**Madison Landmarks Commission**

University Heights Historic District  
 Criteria for the review of additions, exterior alterations and repairs  
 Parcels zoned R2 and R4A

Address: 1827 Summit Avenue  
 Date: July 2, 2008  
 Form Prepared By: K. H. Rankin *KHR*

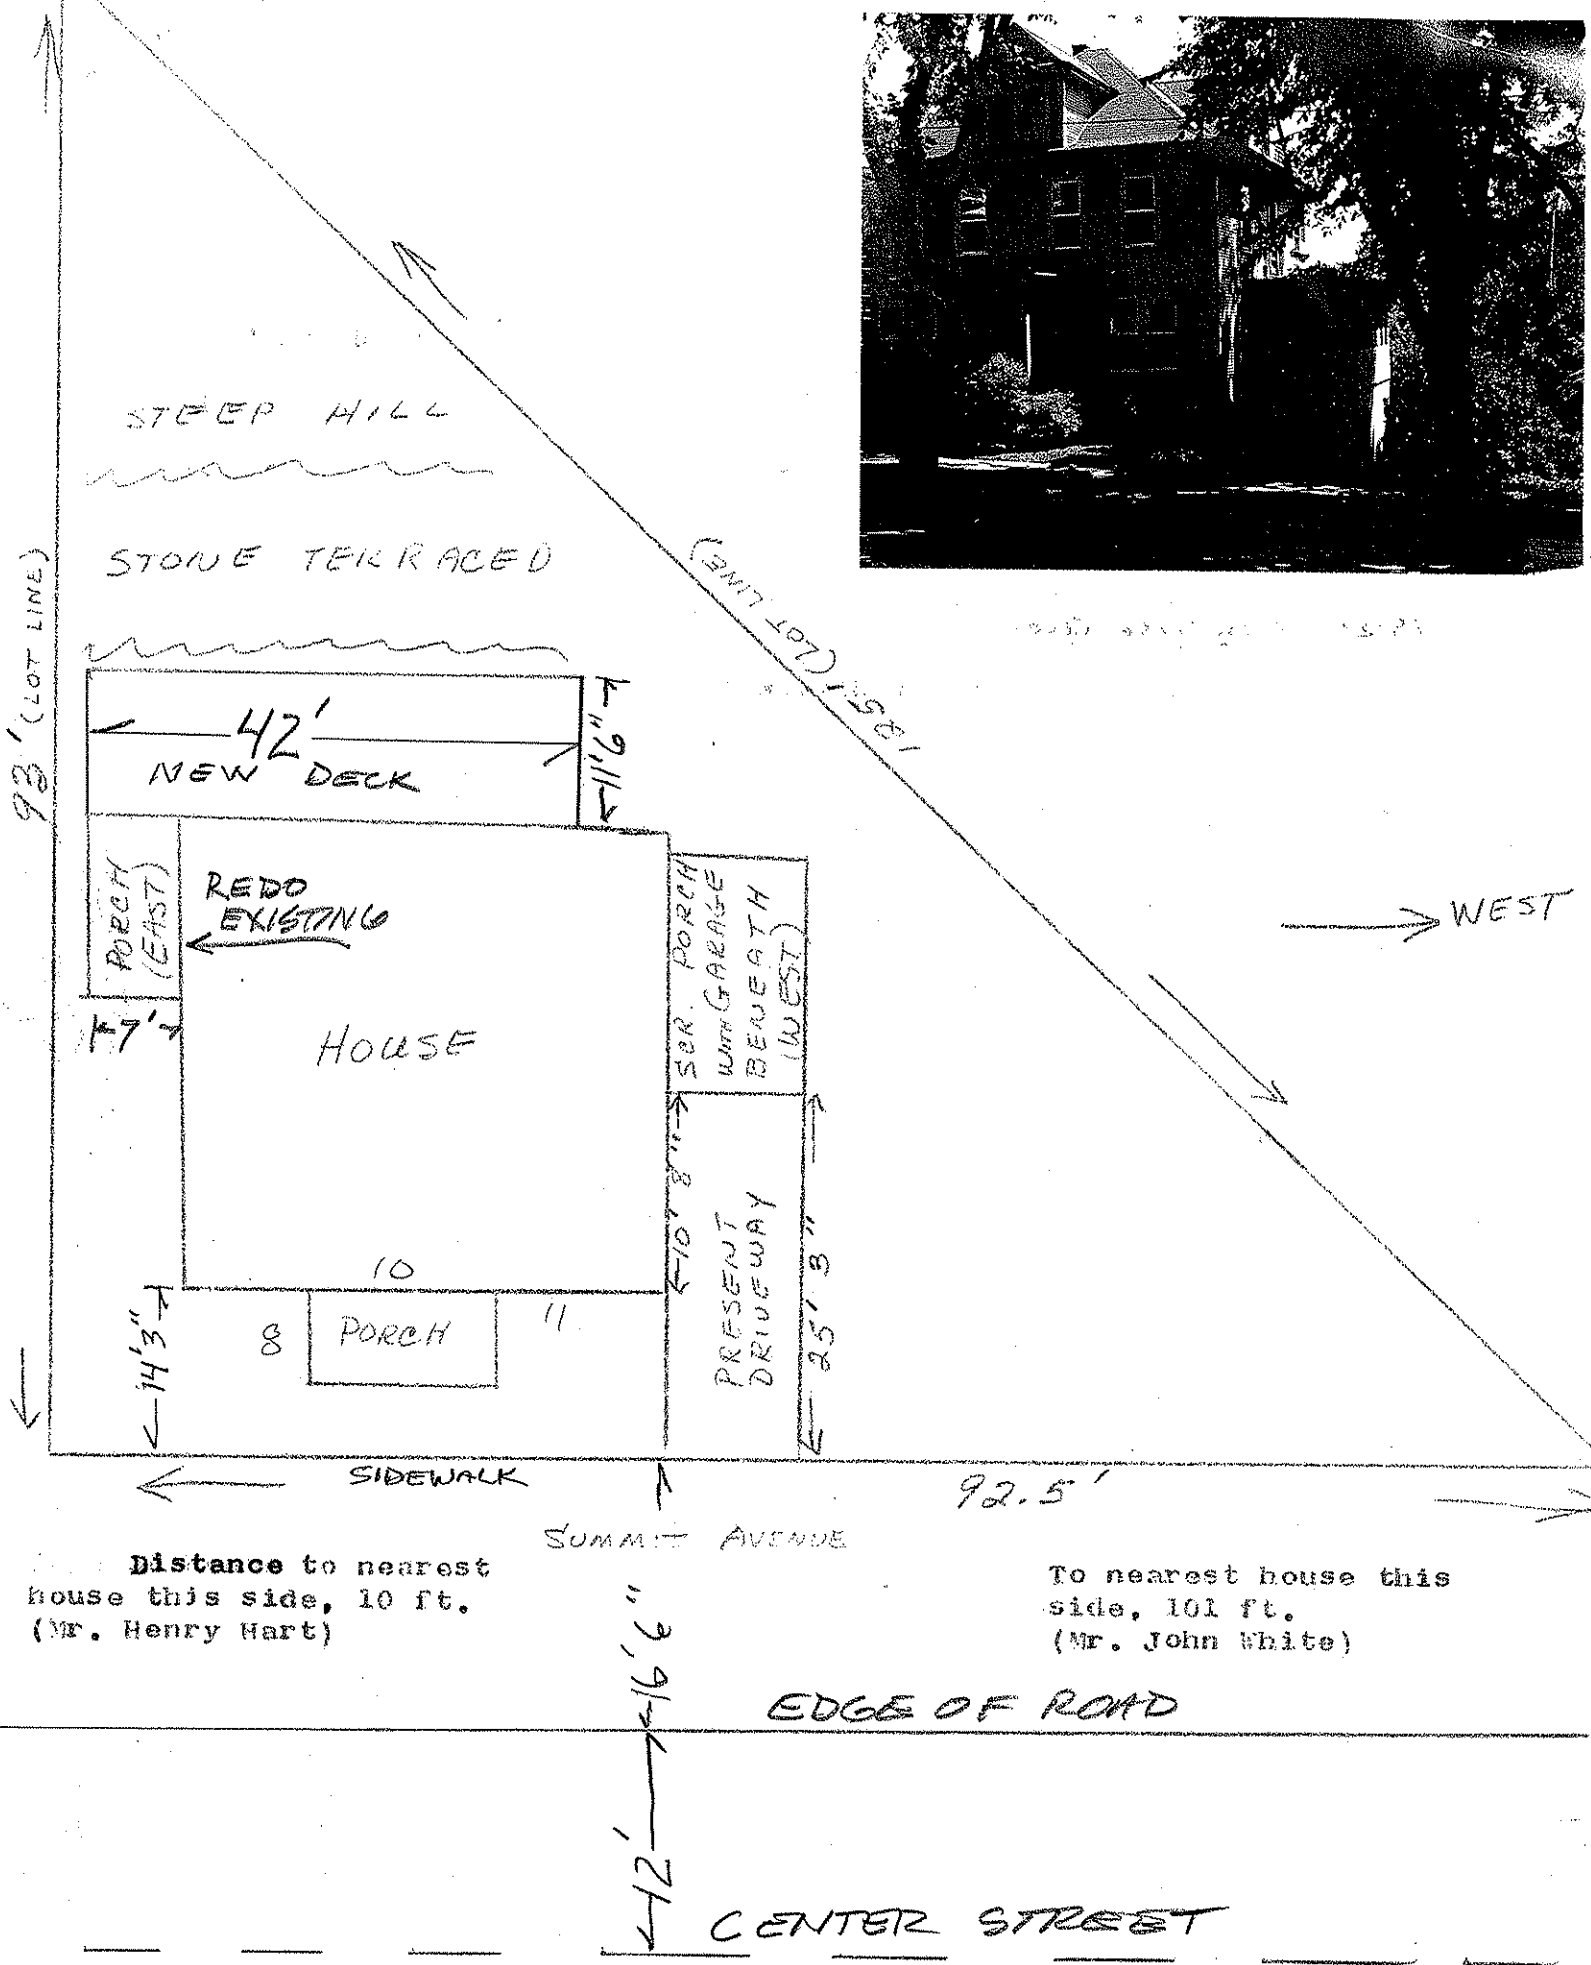
The owner proposes to replace a deteriorating deck on the side of this house and extend it around the rear façade. The rear yard is strongly sloped, so providing this outdoor living area is quite important. It will be somewhat difficult to see this deck from the street because of the slope.

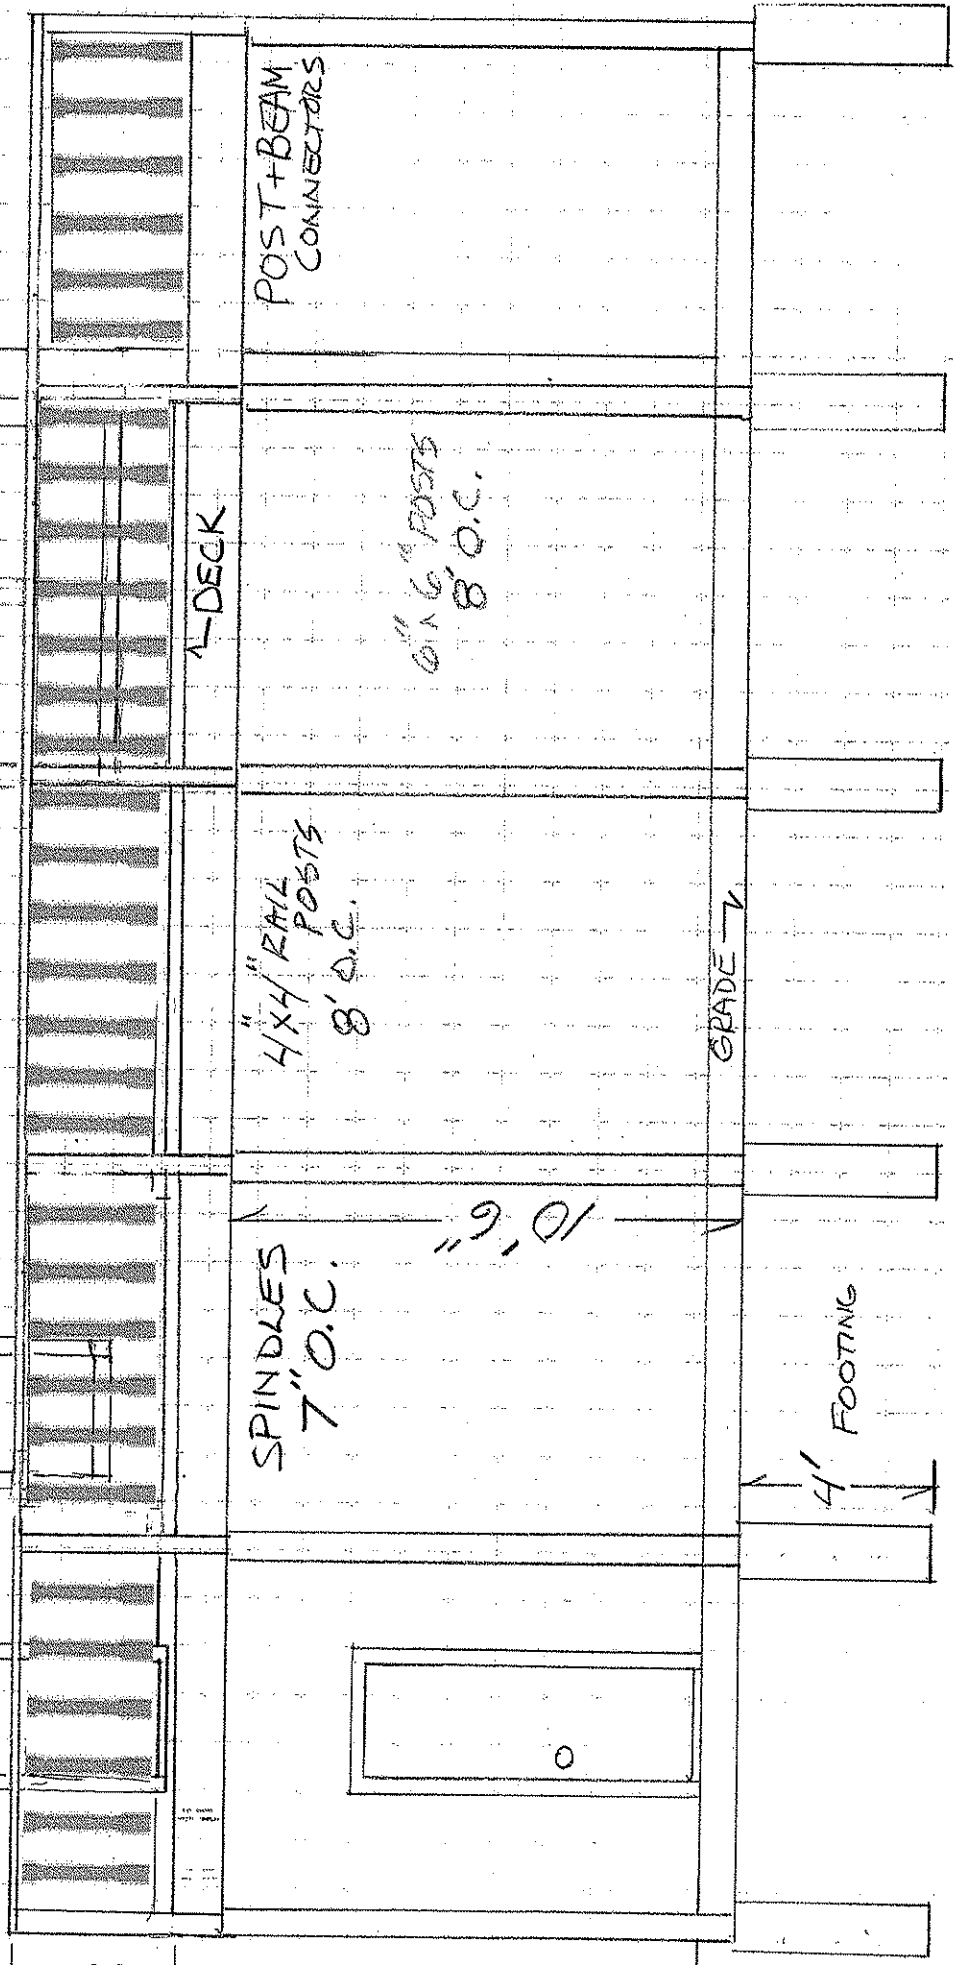
I recommend some slight changes to make the deck more compatible with the house and the neighborhood. I recommend that the four-x-four posts on the deck be masked at their bottoms by the fascia, rather than starting right at the support posts. I also recommend that the four-x-four posts rise a little above the hand rail and have a decorative cap. Also, the spindles will need to be closer together to meet code. I also recommend that a lattice be installed on the frontmost elevation of the new deck to screen the long posts from the street. Finally, all wood except the decking should be painted or opaque stained to blend with the color of the house.

With these changes, I recommend approval.
